**RE: Response to Request for Information DA2024/1376
7 Cooleena Road ELANORA HEIGHTS**

I refer to the above development application and in particular Council's letter (RFI) of 10 January, 2025, to which the following reply is provided:

Fig 1: Extract of Site plan

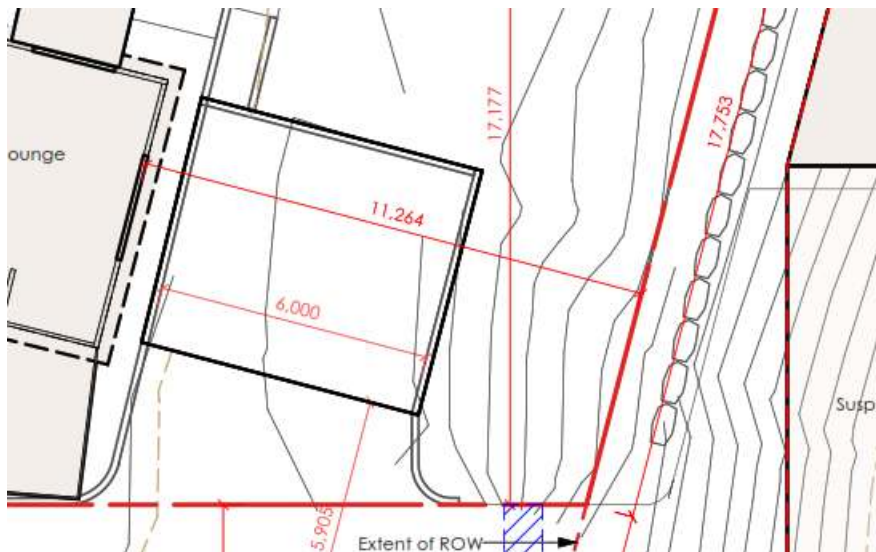
4. PDCP C1.5 – Privacy

The design of any future dwelling house on Lot 2 will not be constrained by potential overlooking impacts from the existing dwelling house. In this regard, the living room windows of the existing dwelling are located some 11.26 metres from the propped common boundary, with the future dwelling being further setback. Such significant separation does not warrant any special design attention or mitigation measures (as it is more than 9 metres away) as per the DCP control at C1.5 which states:

Private open space areas including swimming pools and living rooms of proposed and any existing adjoining dwellings are to be protected from direct overlooking within 9 metres by building layout, landscaping, screening devices or greater spatial separation as shown in the diagram below (measured from a height of 1.7 metres above floor level).
